Ridgeway Arizona Oil Corp (Ridgeway) requests approval to plug and abandon the Farrell Federal #14 according to the attached proposed plugging procedures and well bore diagram.

Plugging Procedure
Farrell Federal #14
API – 30-041-10432
Sec. 28, T7S, R33E, UL-C
660' FNL 1980' FWL

**Farrell Federal 14
30-041-10432
Ridgeway Arizona Oil Corp
November 21, 2017
Conditions of Approval**

Co. Rep	0	
Well Name	Farrell Federal	Well No. 14
Field	Chaveroo San Andres	
County	Roosevelt	
State	NM	
Date		
Date Comp		
KB	4422 RDB

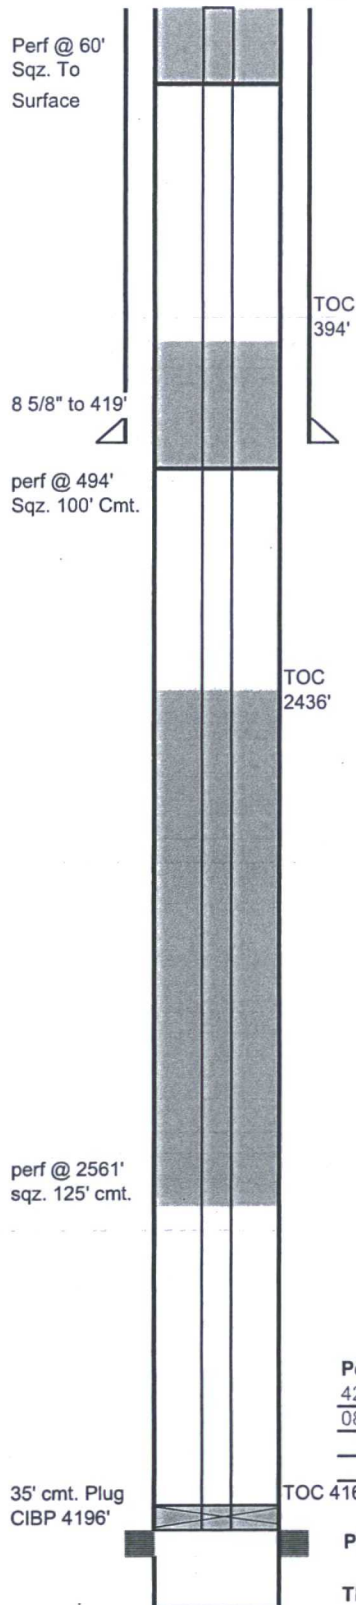
salt plug added/ plugs altered.

4191' (50' - 100' above top most perf)

*2200' (to seal the top of the gates)
* salt plug added. see CoAr*

394' (50' above + 50' below the shoe)

1. Operator shall place CIBP at 4,191' (50'-100' above top most perf) and place 35' of Class C cement on top as proposed. WOC and TAG.
2. Operator shall perf and squeeze at 2,561'. Operator shall place a balanced Class C cement plug from 2,561'-2,200' to seal the top of the Yates formation. WOC and TAG.
3. Operator shall place a Class C cement plug from 1,900'-1,700' to seal the salt.
4. Operator shall perf and squeeze at 494' as proposed tagging plug at 369' to seal the surface shoe. WOC and TAG.
5. Operator shall shall perf and squeeze at 60' brining cement to surface.
6. See Attached for general plugging stipulations.
